Carbon Resources, LLC  
PO Box 954  
Sandia Park, NM 87047  
Telephone: (505) 286-1253

RE: PERMIT APPLICATION RESPONSE TO DEFICIENCIES, TASK ID# 3779 DATED 5/2/11 FOR KINNEY NO. 2 MINE - PERMIT NO. C/007/0047

Title: Response to 5/2/11 Deficiencies Task ID#3779

FIGURE  
25A

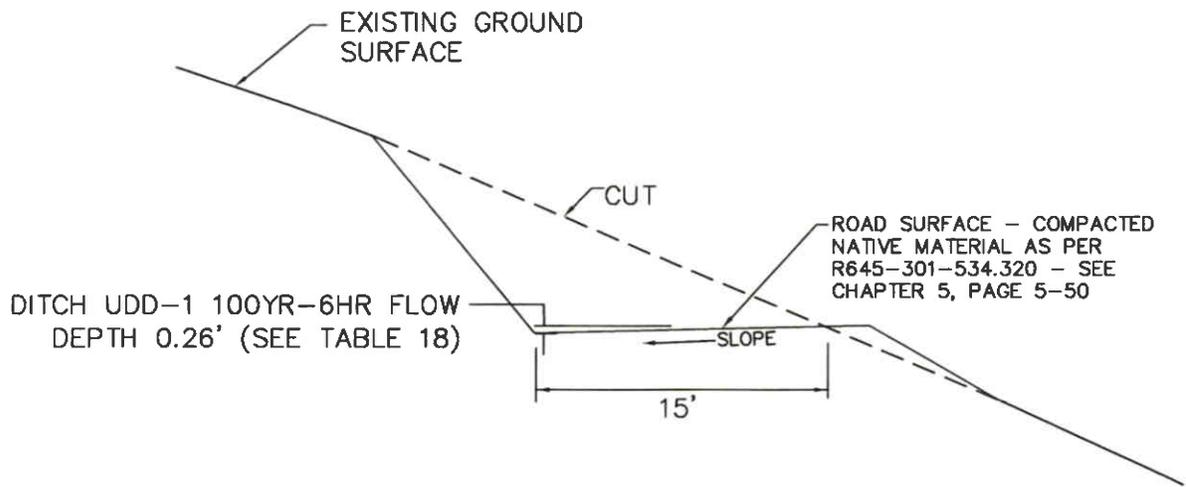
All other roads will be constructed as shown on Figure 25, Typical Primary Road Configurations, and Figure 25A, Primary Roads P8 & P9 Configuration for sloping terrain and level terrain.

All other roads will be constructed as shown on Figure 25, Typical Primary Road Configurations for sloping terrain and level terrain, and Figure 25A, Primary Roads P8 & P9 Configuration for roads P8 and P9.

NOTE: WATER BARS TO BE PLACED AT GRADE CHANGES AND/OR AT 300' SPACING OR PER US FOREST SERVICES STDS, WHICHEVER IS LESS

Figure 15. Underground Horizontal Monitor Well Completion

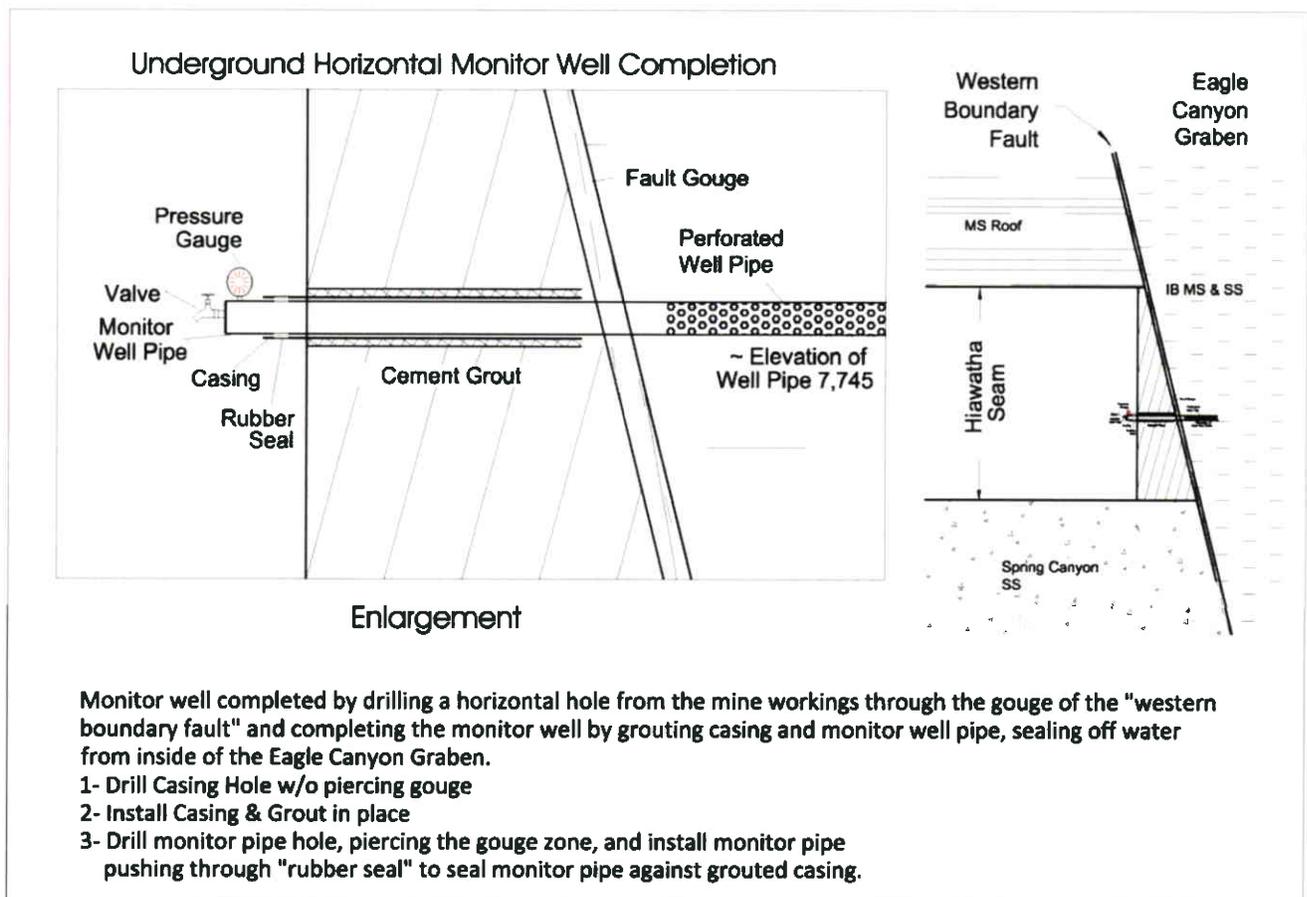
As a result of CR-06-03-ABV being decommissioned only six months of groundwater data were collected from within the Eagles Canyon Graben. Carbon Resources commits to replace CR-06-03-ABV with an in-mine monitor well. As mining extends eastward to the Western Boundary Fault of the Eagles Canyon Graben Carbon Resources will complete an in-mine monitoring well to monitor ground water inside of the Eagles Canyon Graben. Due to the differential in water level within the Eagles Canyon Graben and immediately west of this Graben, a monitor well will consist of piercing the gouge zone of the graben and installing a grouted-in differential pressure gauge and valve to monitor the water level and quality within the Eagles Canyon Graben, Figure 15.

**FIGURE 17. FIELD DATA**

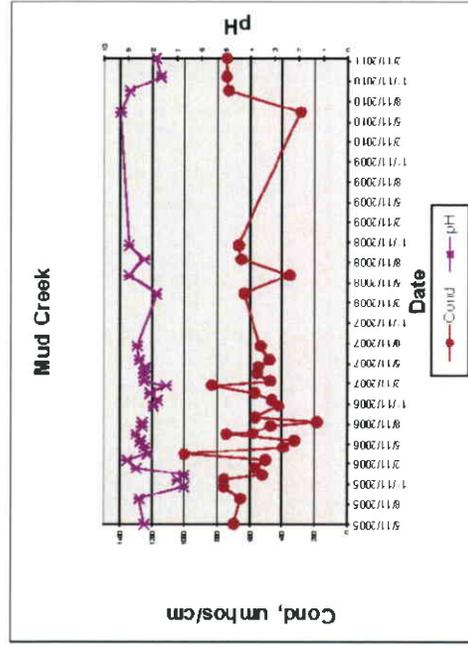
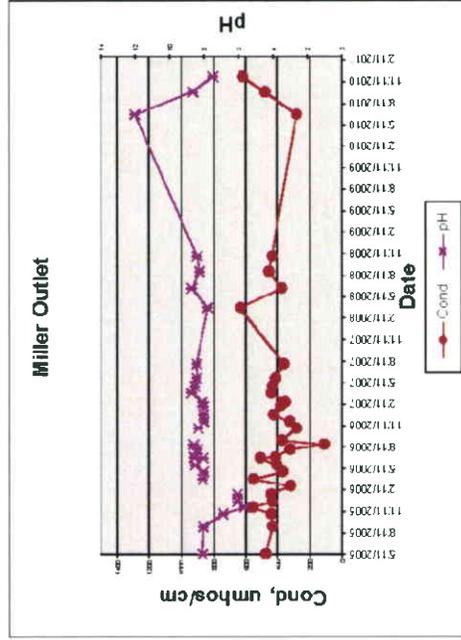
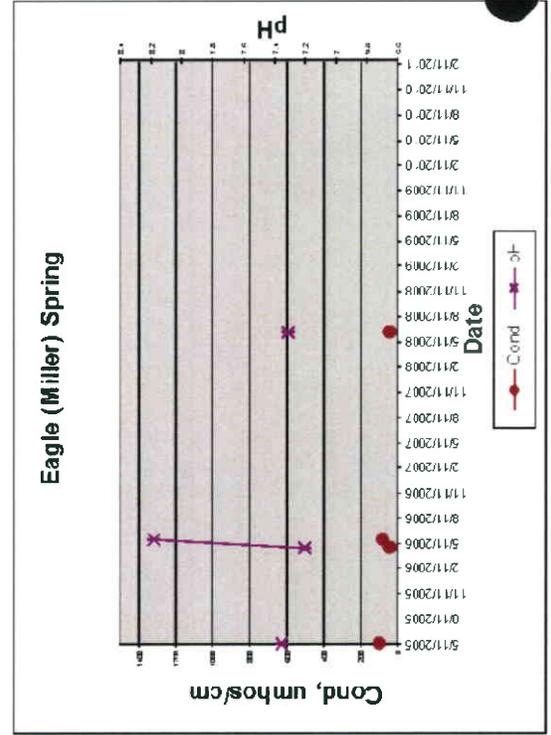
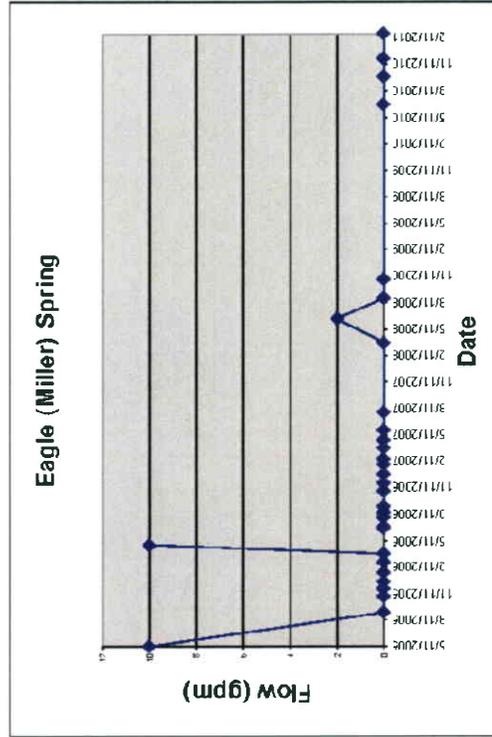
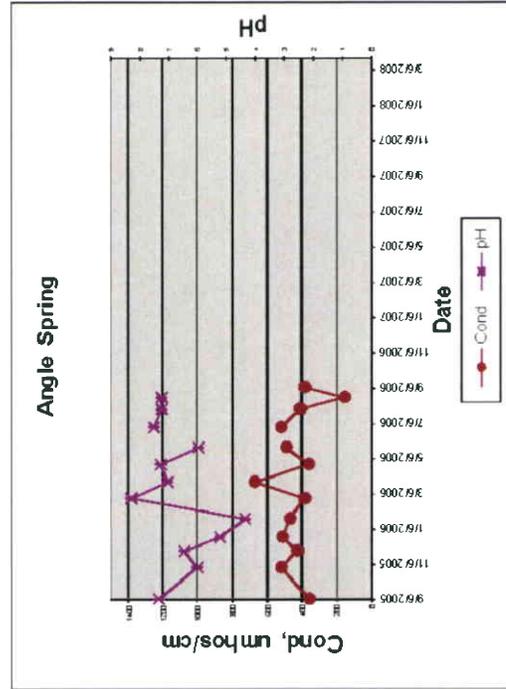
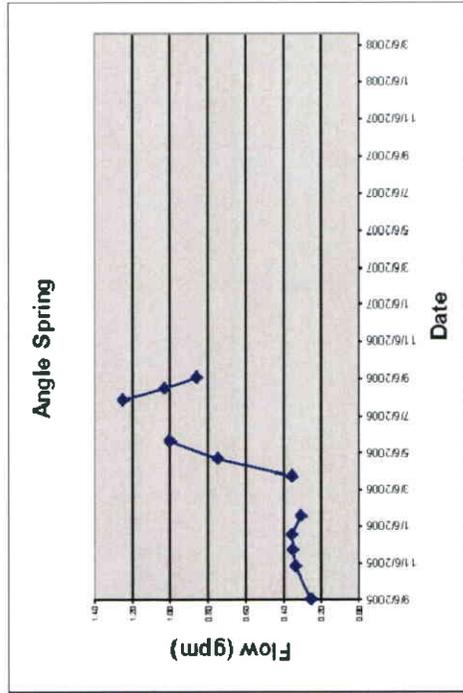
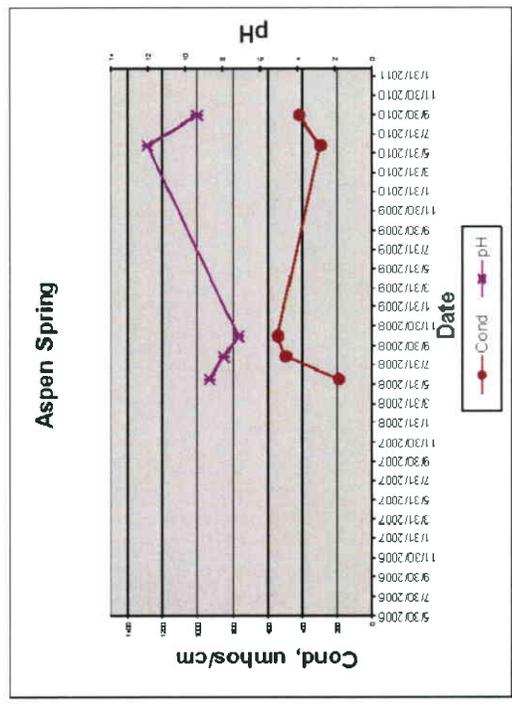
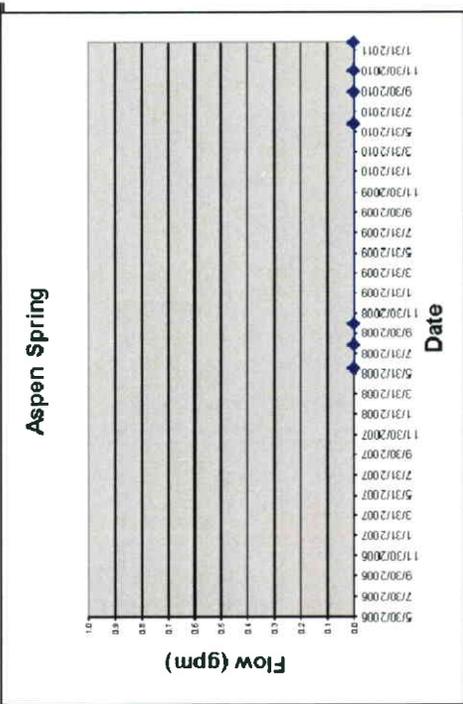
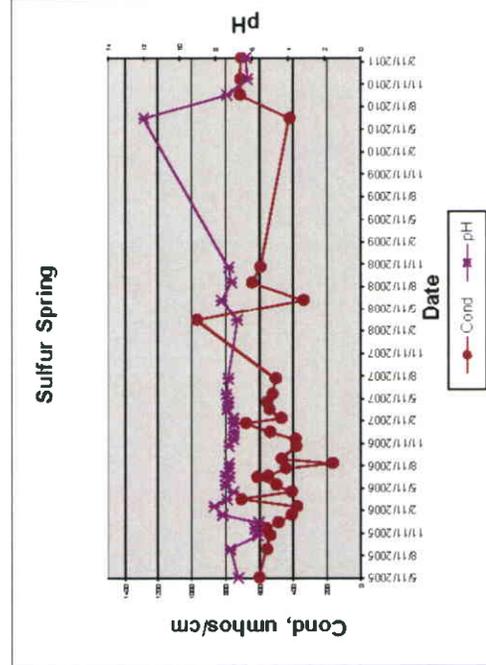
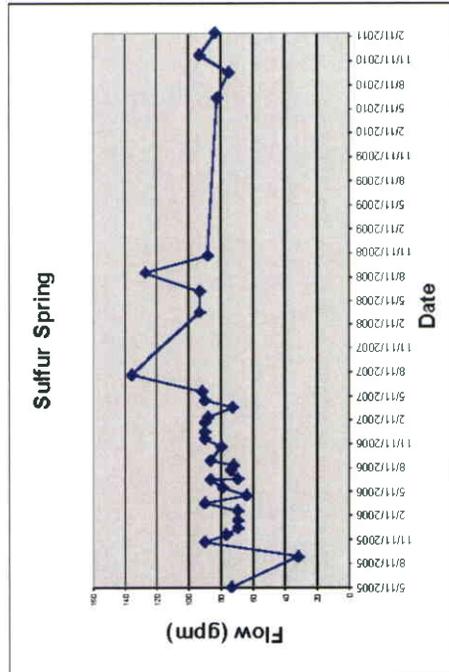
Water levels reported on Exhibits 10 and 11 were erroneously labeled as SWL "static water level" even when most of the water levels were simply stagnant water trapped inside of the blank. This was done because prepares of this MRP are hapless dolts. The term static water level has been replaced with "water level" on all Exhibits 10 and 11 and Figure 17.

Carbon Resources LLC  
**RECEIVED**  
 KINNEY NO. 2 MINE  
 MAP 22  
 MOUNTAIN SURVEYING  
 ROAD PROFILES

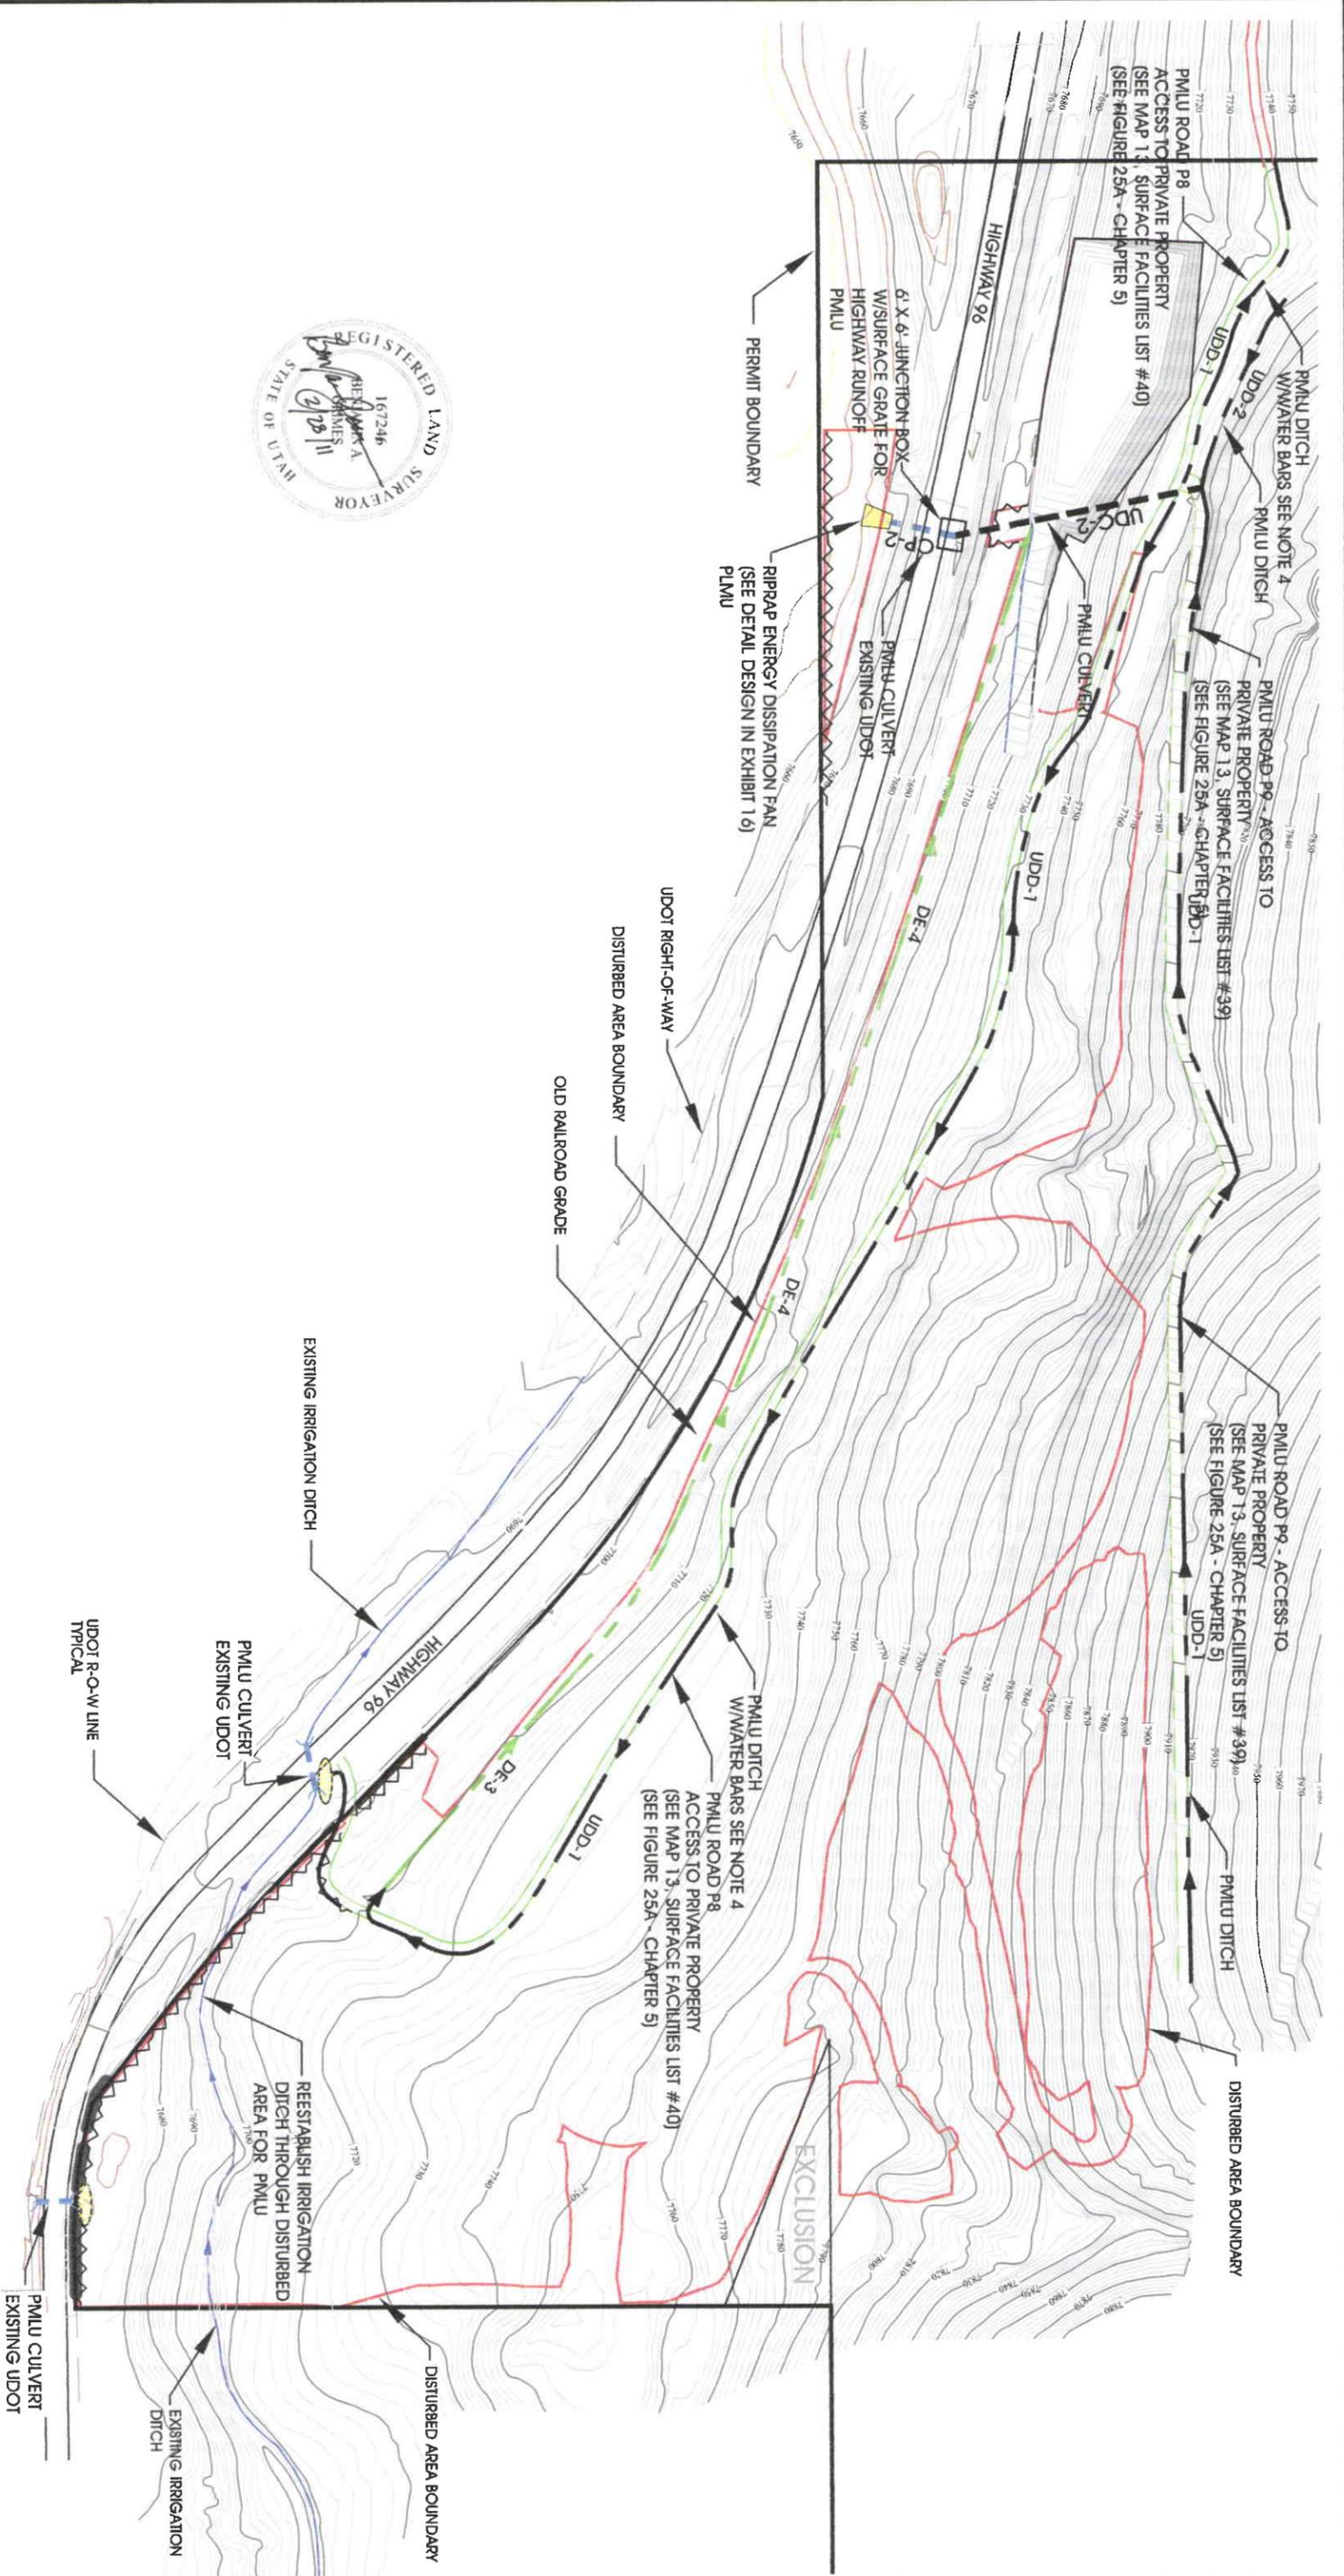
NOTE: ROAD P9 IS A REPLACEMENT FOR AN EXISTING ROAD TO ALLOW PRIVATE PROPERTY OWNER ACCESS TO THE MOUNTAIN EAST OF THE MINE SITE, AND IS A POST MINING LAND USE ROAD. IT IS SIMILAR IN GRADE TO THE EXISTING ROAD IT REPLACES - SEE FIGURE 25A FOR TYPICAL CROSS SECTION

NOTE: ROAD P8 IS A POST MINING LAND USE ROAD AND FOLLOWS THE RECLAIMED SURFACE WITH MINOR CUTS AND FILLS - IT ALLOWS ACCESS FOR PRIVATE PROPERTY OWNERS NORTH AND EAST OF THE MINE SITE. IT REPLACES A PRE-MINING ROAD - SEE FIGURE 25A FOR TYPICAL CROSS SECTION

NO.	REVISION	DATE	BY	CHKD	DWG. NAME:
1	CERTIFIED	3/5/11	B.G.	G.H.	ROAD PROFILES
2	ADDED ROADS P8 & P9	4/23/11	B.G.	G.H.	
3					
4					
5					
6					
7					
8
